RATIONALE

(R) FITTING, ELBOW, 45°,
FLARED TO PIPE

AS5196™
SHEET 1 OF 4

REV.
D

FIGURE 1 - FITTING, ELBOW, 45°

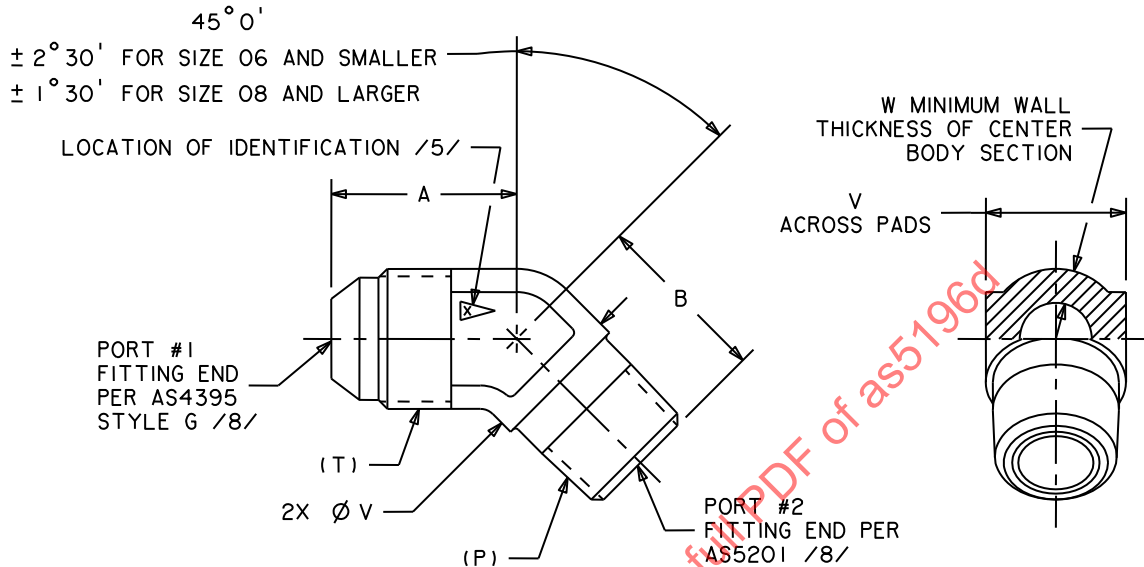
"INACTIVE" STATUS REPLACED BY "NOT RECOMMENDED." CADMIUM WARNING NOTE RELOCATED AS FIRST NOTE. ALTERNATE MATERIALS ADDED TO NOTE 1. SPECIFICATION CALLOUTS UPDATED TO CURRENT ISSUE. NOTE 3.g.2 REVISED. QML STATEMENT REVISED. "INTENDED USE" NOTE REVISED. NEW NOTE 18 ADDED.
